Steinborn Residence

Date:
2/19/2023 Permit Approval
8/24/2023 Permit Rev. Sub
12/6/2024 Permit Rev. Sub

CHEN RESIDENCE

New Residence

Roof
Plan
A2.3

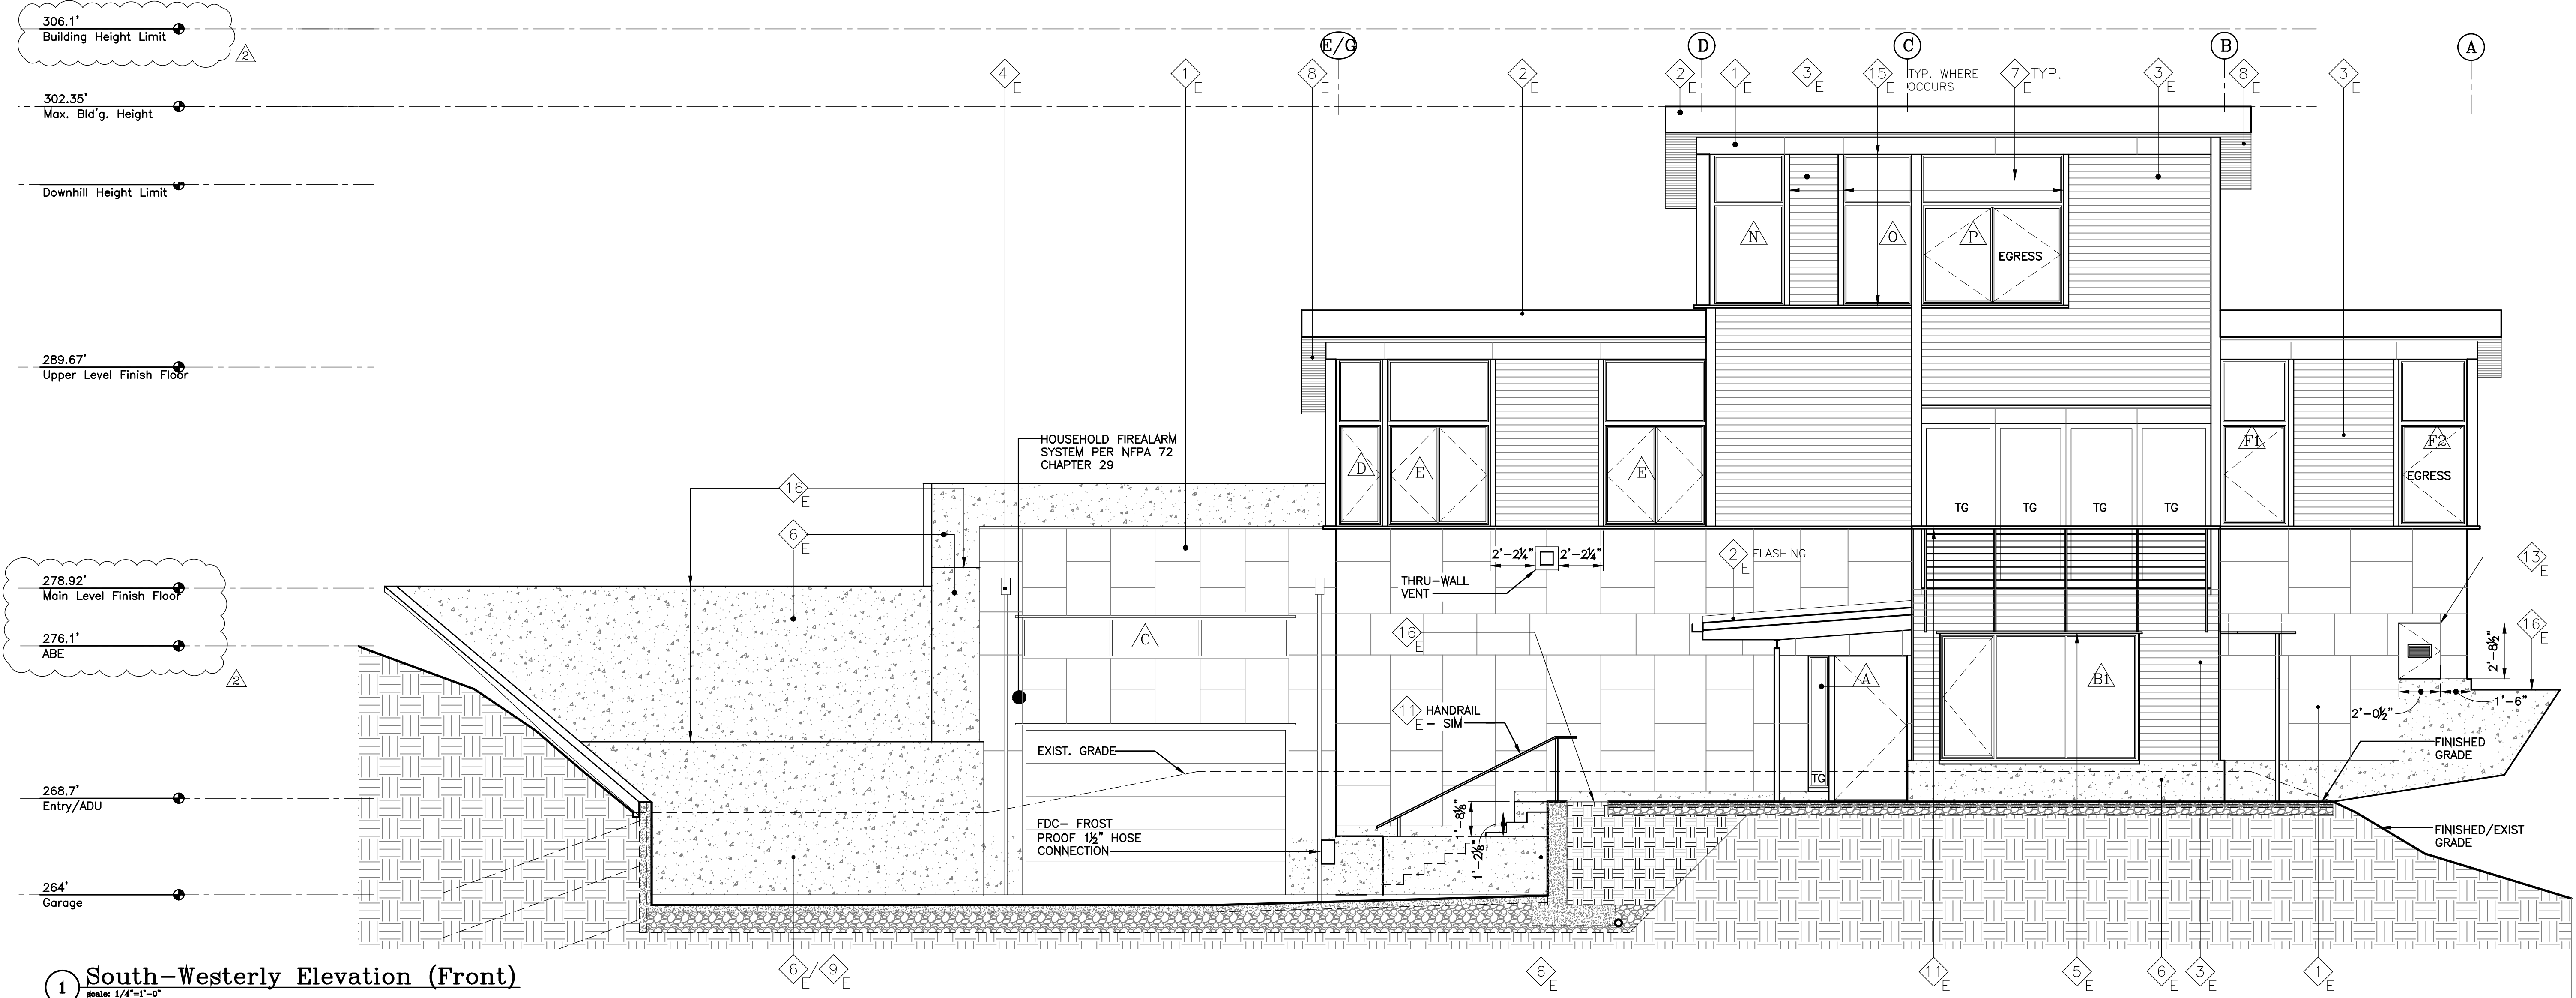
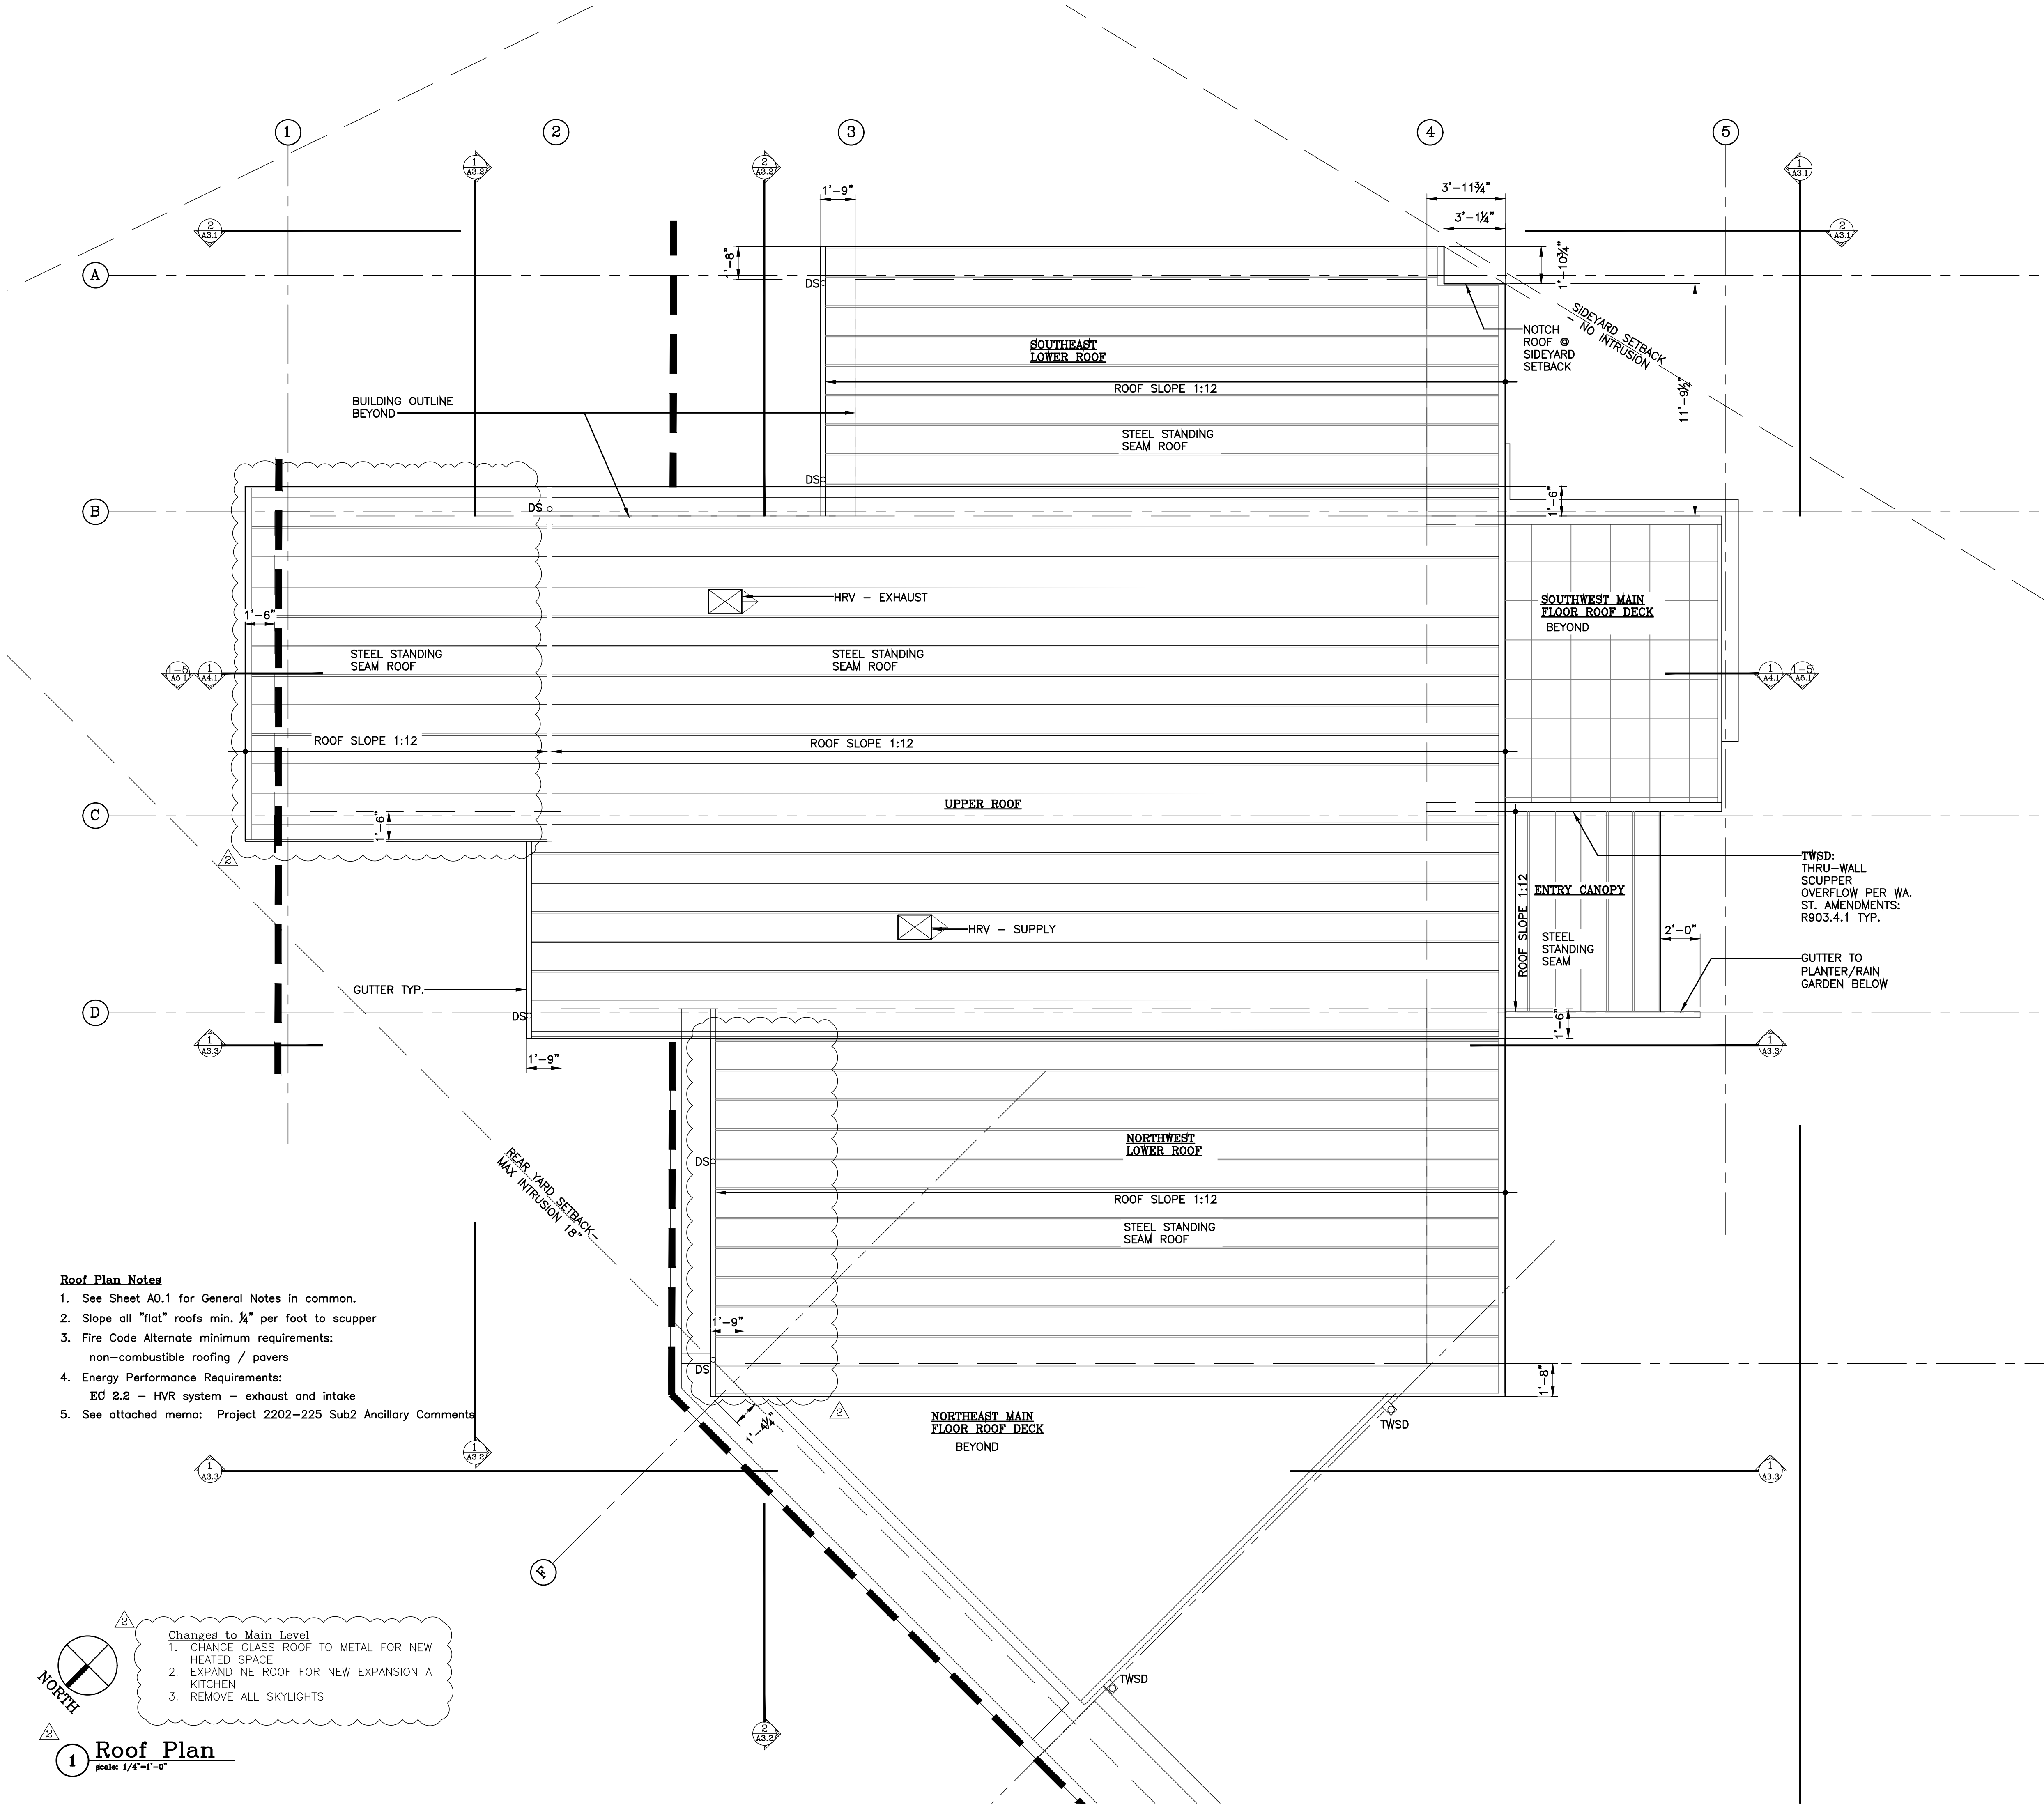
- CHANGE GLASS ROOF TO METAL FOR NEW HEATED SPACE
- EXPAND NE ROOF FOR NEW EXPANSION AT KITCHEN
- REMOVE ALL SKYLIGHTS

Elevations/
Sections
A3.3

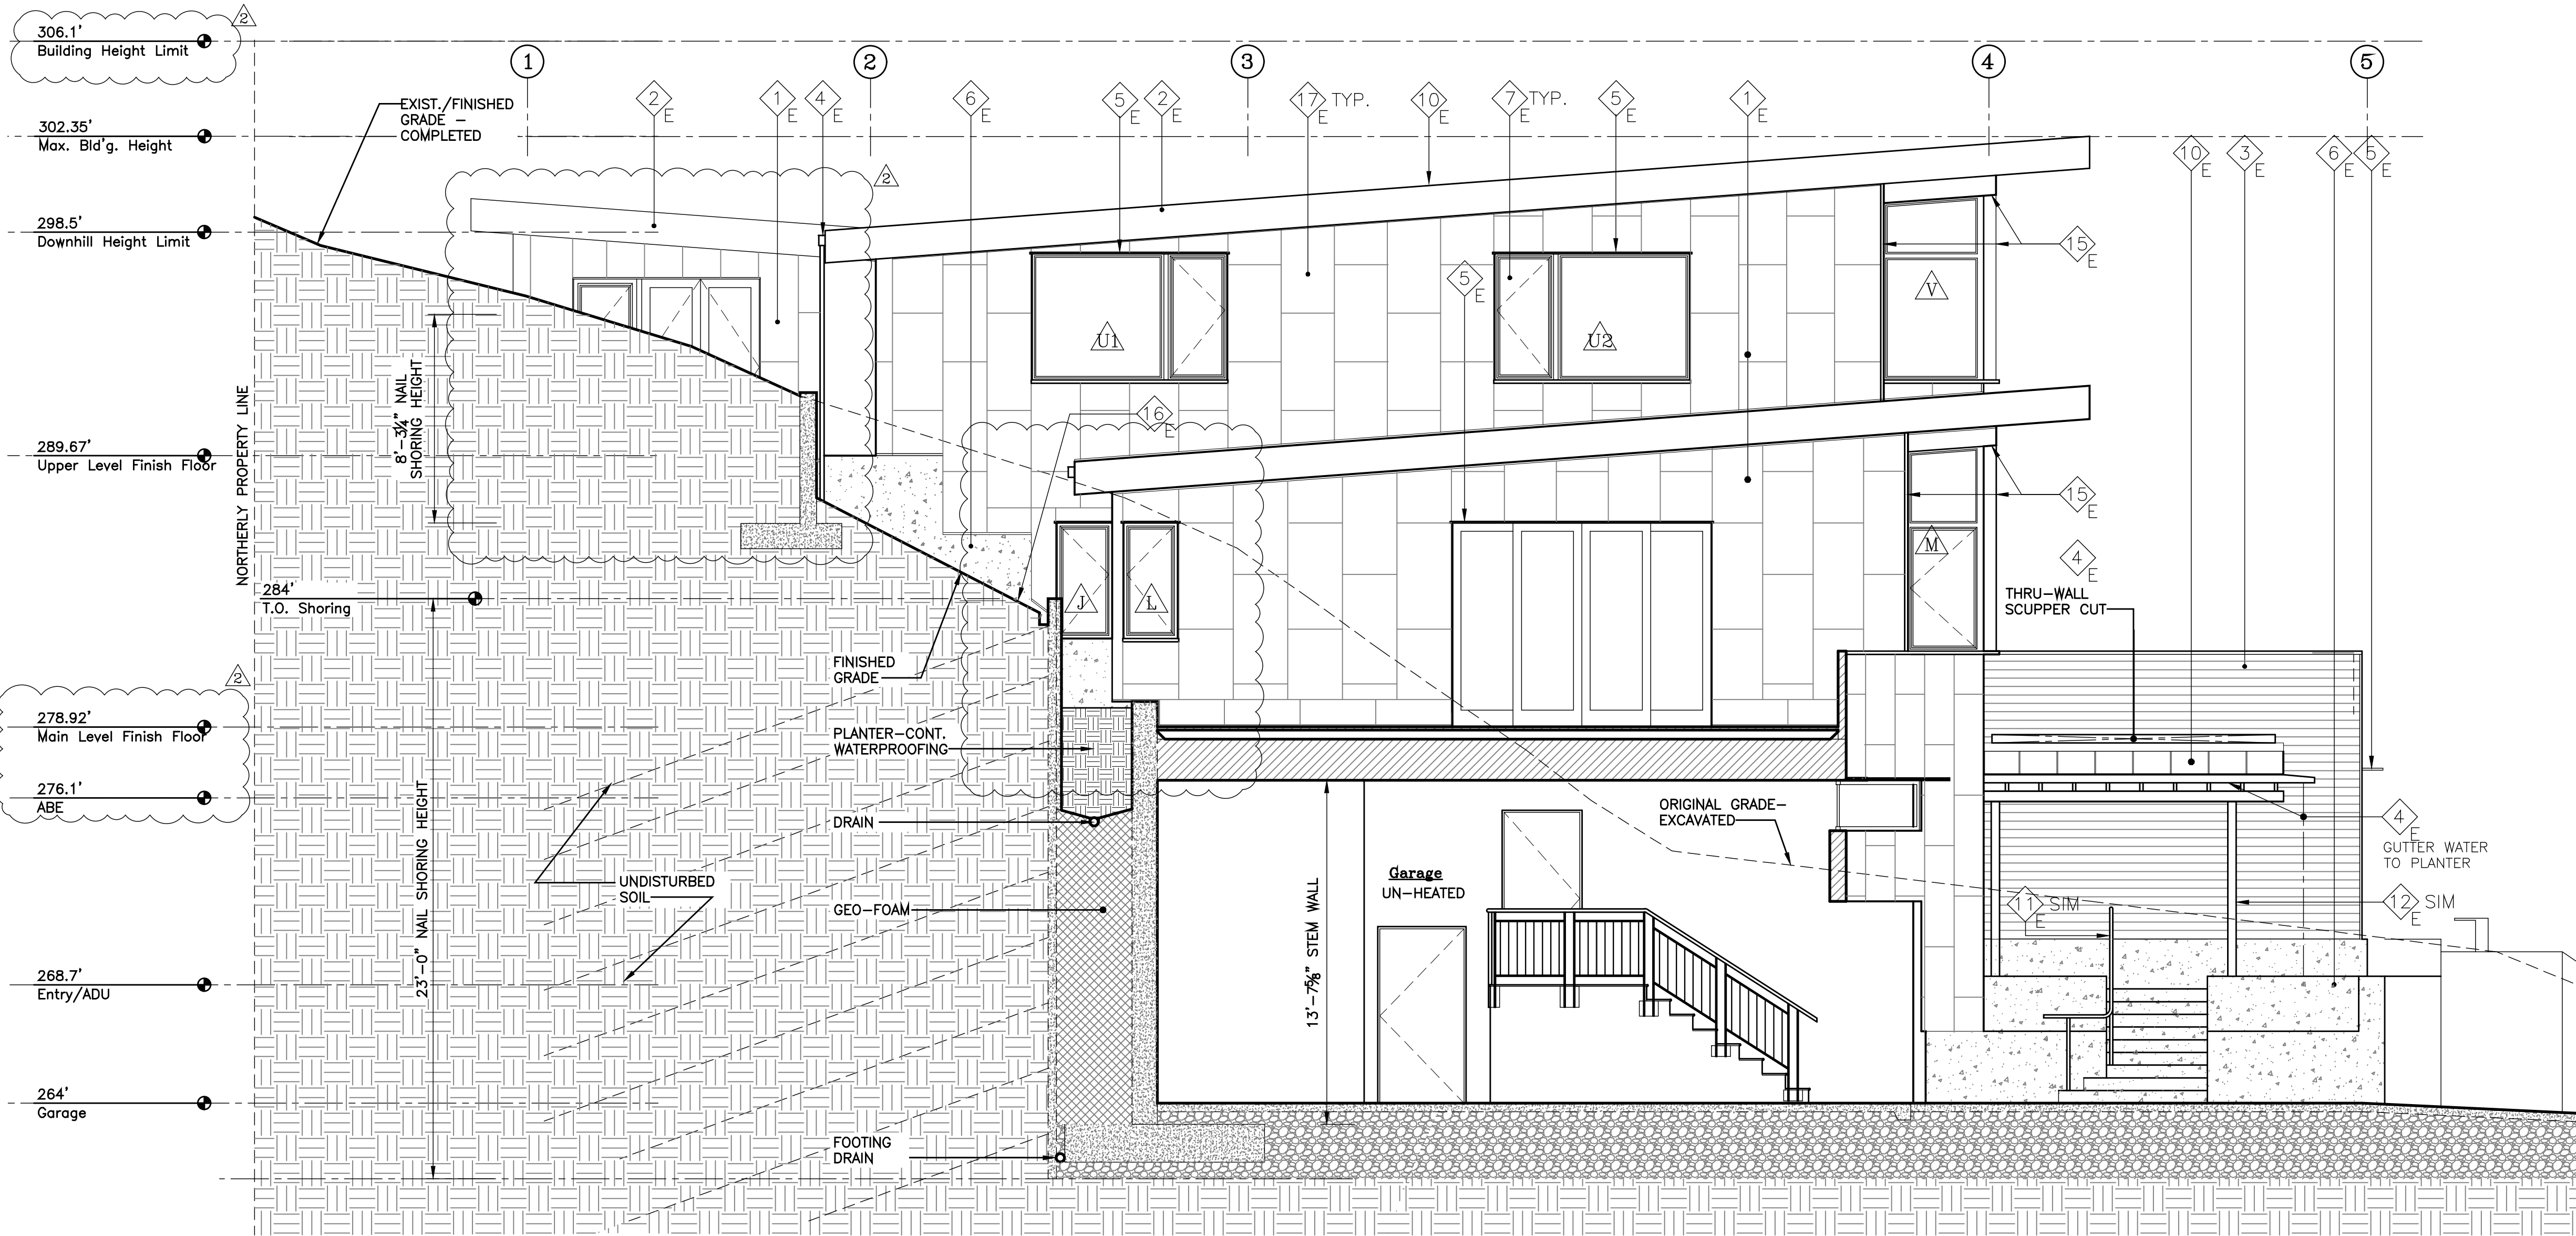
- CHANGES TO ELEVATIONS
- 1. ABE/MAX BUILDING ELEVATION/HEIGHT
 - 2. WINDOW/DOOR CONFIGURATION ON MAIN/UPPER FLOORS
 - 3. MAIN FLOOR ELEVATION LOWERED
 - 4. INFILL OF COVERED PATIO @ UPPER FLOOR WITH HEATED SPACE
 - 5. INFILL OF DBL. HEIGHT SPACE @ DINING AREA
